PRODUCT CHANGE NOTIFICATION

REVISED JULY 22, 2024

Select Riedon™ Shunts and Fuse Blocks by Bourns

Relocation of Manufacturing Site and Changes to Part Marking, Packaging Label and Packaging

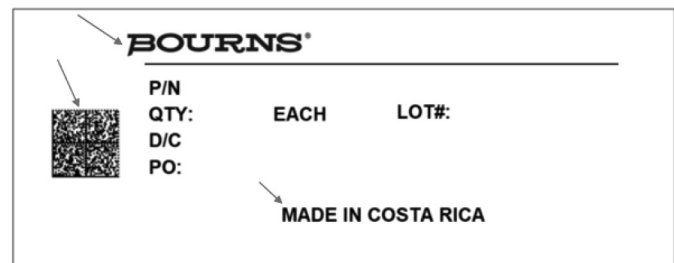
Current Packaging Label

New Packaging Label

Current Part Marking - Shunts

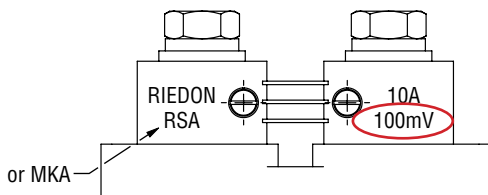
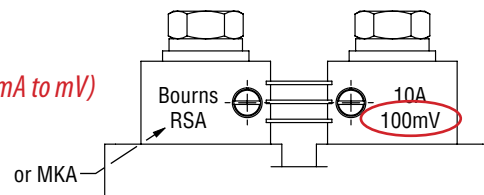
(Correction from mA to mV)

New Part Marking - Shunts

The fit, function, quality and reliability of all affected part numbers will remain the same. The form will slightly change due to the Bourns logo replacing the Riedon logo in the part marking. The Heredia, Costa Rica facility is IATF qualified. Traceability will be maintained through date code. The data sheet will change to the standard Bourns format.
